X 95.002-26

## 254XP/257/262XP

## Clutch drum

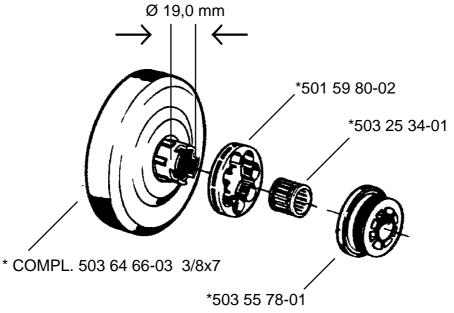
A new material has been introduced for all clutch drums. The new material gives a longer service life and improves the saw's braking times.

Due to reasons of co-ordination the connection against the oil pump worm wheel has been changed at the same time as the new material is introduced on all 3/8 versions from  $\varnothing$  20.5 mm to  $\varnothing$  19.0 mm, i.e. the same size as on the 0.325 drum. To be able to replace the old clutch drum the oil pump worm wheel\* 503 55 78-01 is supplied with the complete 3/8 drum.
